Design differences on POE section.

Dated-27/10/2025

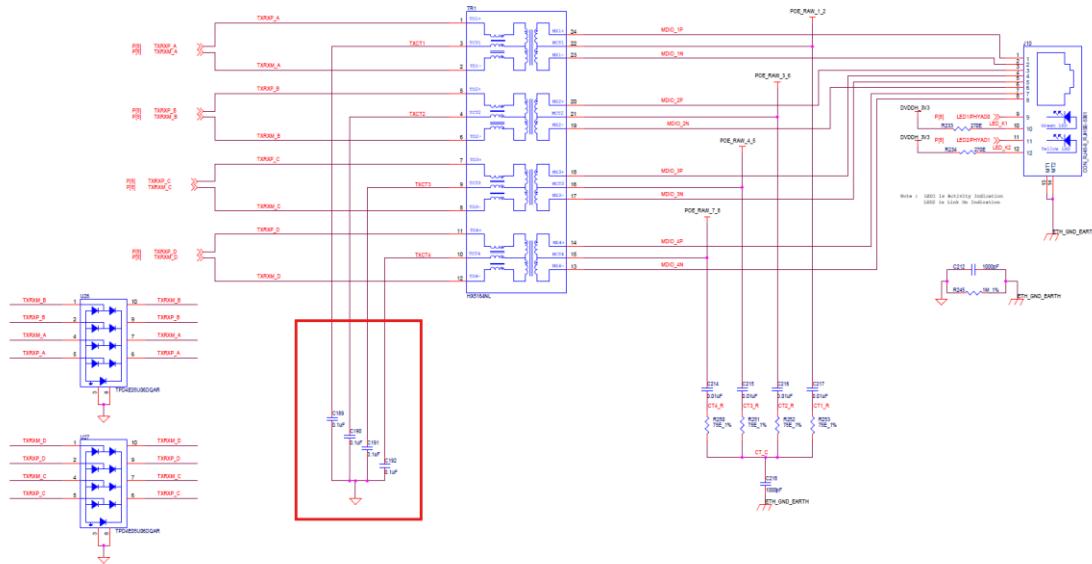
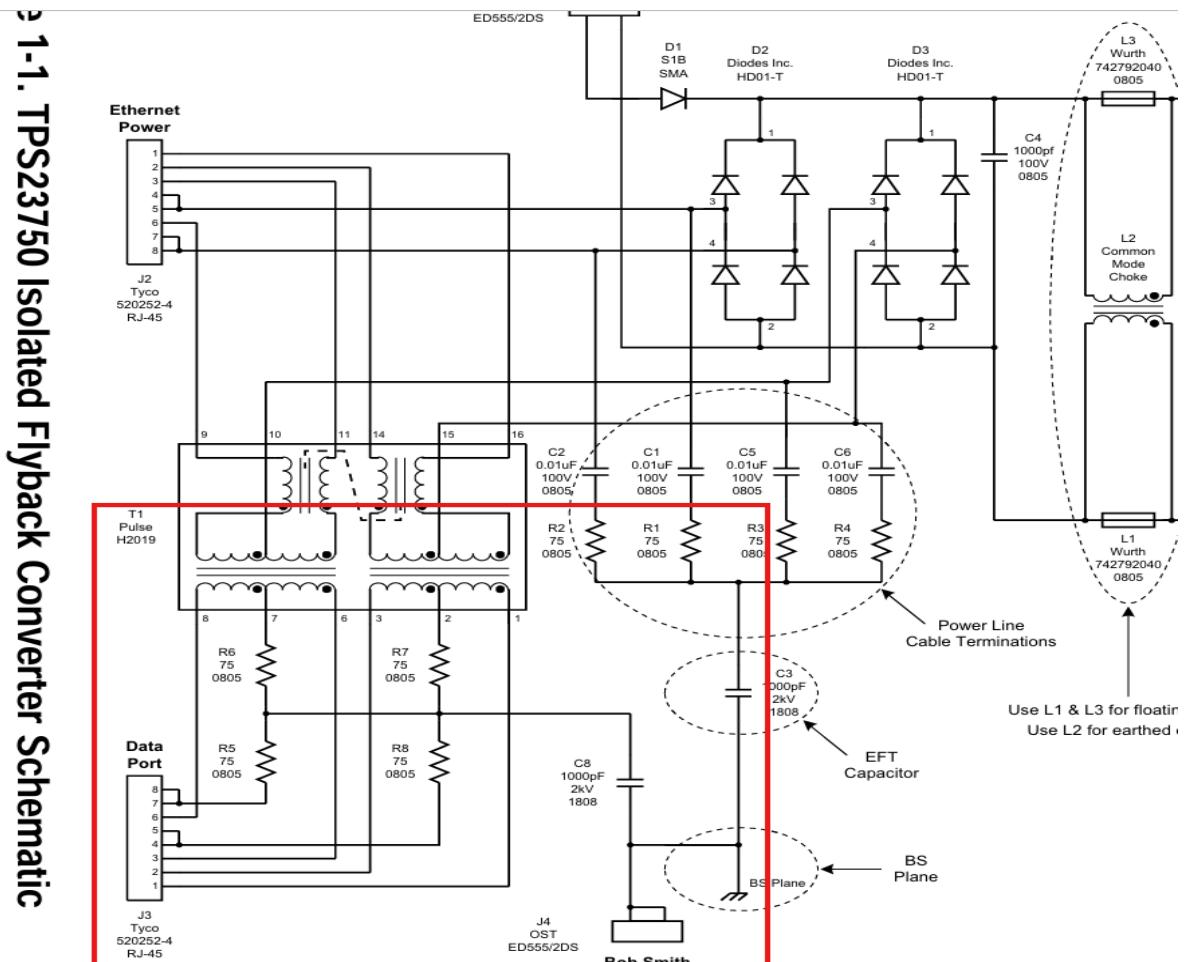
- We observed that the Ethernet data lines in our design do not include the 75Ω resistors that are present in the TI reference design

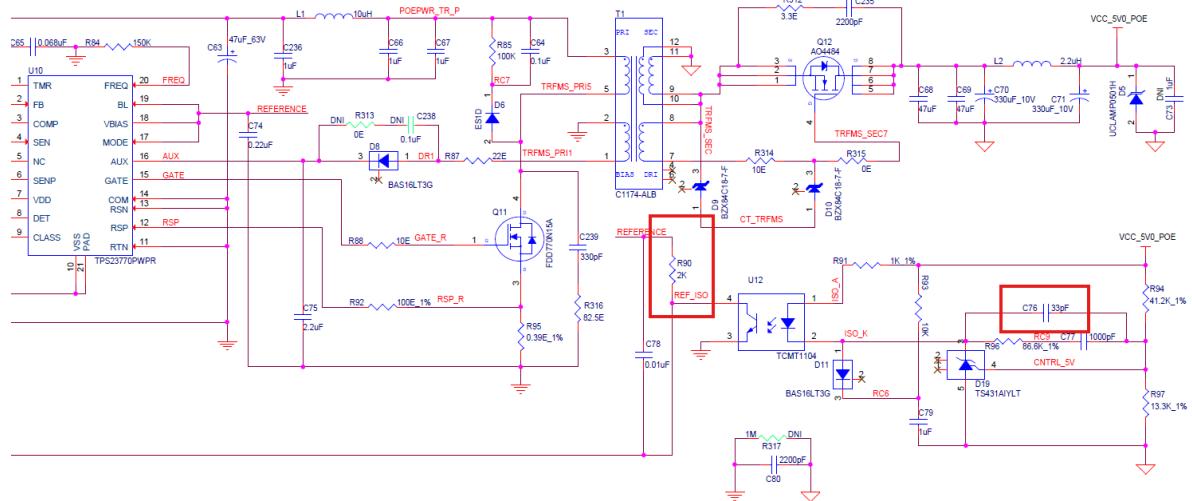
- Another difference we observed between the reference design and the Mistral design is that the snubber circuit on the collector of the U12 opto-isolator is not present in our design. Additionally, the C76 capacitor is populated in our design, whereas it is marked as DNI in the reference.
